Project	IEEE 802.16 Broadband Wireless Access Working Group < http://ieee802.org/16 >	
Title	Clarification of SNR definition for MIMO	
Date Submitted	2005-01-13	
Source:	Ming Jia,, Peiyong Zhu, Wen Tong, Jianglei Ma, Mo-Han Fong, Hang Zhang, Brian Johnson Nortel Networks 3500 Carling Avenue Ottawa, ON. K2H 8E9 CANADA	Voice: (613)-765-8089 Fax: (613)-765-7723 pyzhu@nortelnetworks.com
Re:	Call for Reply Comments regarding the Maintenance Task Group Comment Report 80216maint-04_09.zip	
Abstract	In this contribution, we propose to feedback CQI based on SNR measured after MIMO decoder and before FEC encoder, so called post processing SNR to provide a unified approach for MIMO CQI measurement. In the proposal, we also clarify the multiple layer feedback using CQICH_Alloc_IE() or Enhanced_CQICH_Alloc_IE().	
Purpose	The contribution should be considered by Maintenance group within comment resolution procedure

Clarification of SNR Definition for MIMO

Figure 1 Post processing SNR

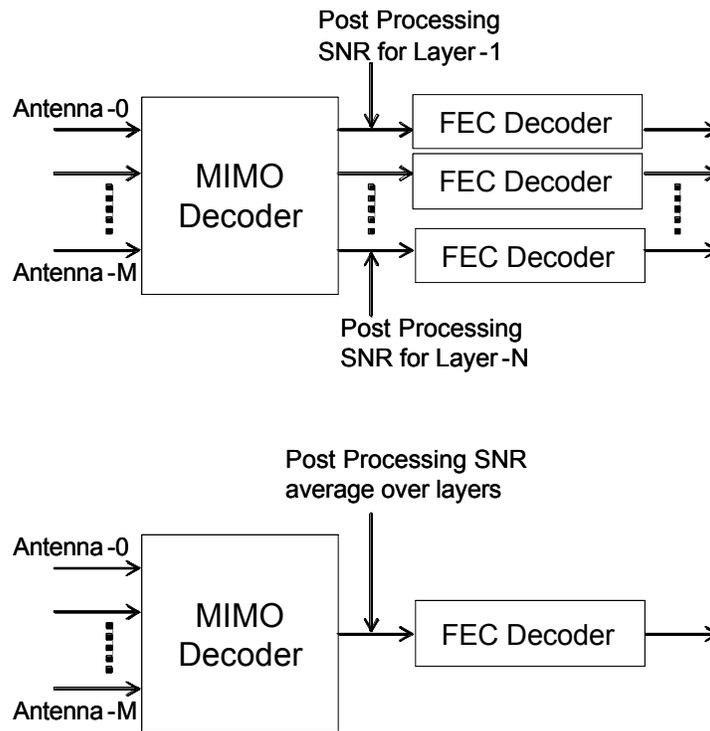
In the current standard, the BS assigns burst profile based on CQI feedback from MSS. For the SISO case, CQI is based on the SNR measured at the receive antenna port. However, for MIMO case, SNR measured at per-receive antenna does not provide enough information for this purpose. The channel burst profile selection depends on the type of MIMO decoder and channel matrix condition. In this contribution, we propose to feedback CQI based on SNR measured after MIMO decoder and before FEC encoder, so called post processing SNR as shown in Figure 1, therefore, provide a unified approach to CQI measurement with all the factors being taken into account. MSS may feedback either average post processing SNR or post processing SNR for individual layer as instructed by BS.

Figure XXX Post processed S/N for MIMO

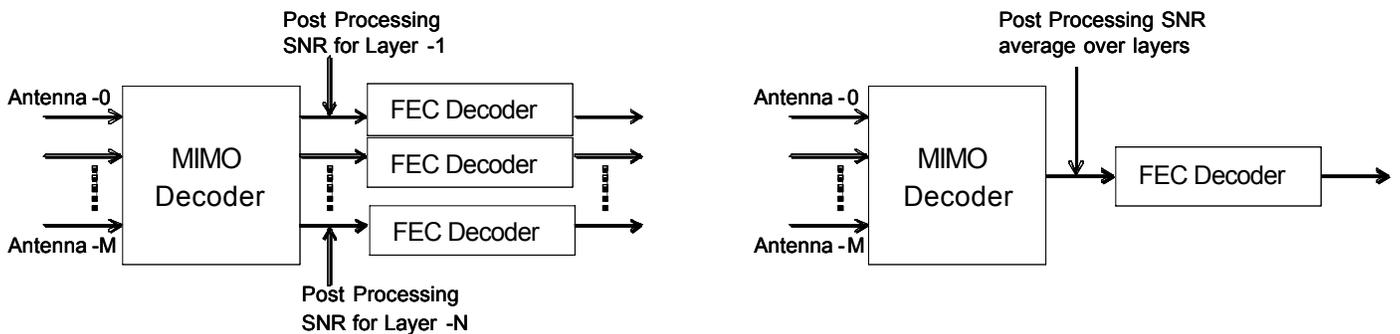
MIMO capable MSS shall measure post processing S/N for each individual layers as shown in Figure xxx. When the FAST_FEEDBACK subheader Feedback Type field is “00”, the MSS shall report the post processing S/R averaged over layers. When BS requests MSS feedback through CQICH_Alloc_IE() or CQICH_Enhanced_Alloc_IE() with ‘00’ Feedback_type field, MSS shall report average S/N or individual layer S/N as described in sections 8.4.5.4.12 and 8.4.5.4.15

For MSS with more than one receive antennas, the following formula shall be used

$$\text{Payload bits Nibble} = \begin{cases} 0 & S/N < -2 - \Delta dB \\ n & 2n - 2 - \Delta < S/N < 2n - 2 - \Delta dB \\ 15 & S/N > 26 - \Delta dB \end{cases} \quad 0 < n < 15 \quad (\text{xxx})$$

where $\Delta = 10 \log(N_r)$ for the cases of single transmit antenna BS or 2 and 4 transmit antenna BS using matrix A transmission format and $\Delta = 10 \log(N_r/2)$ for the case of 2 and 4 transmit antennas BS using matrix B transmission format. N_r is the number of receive antennas.
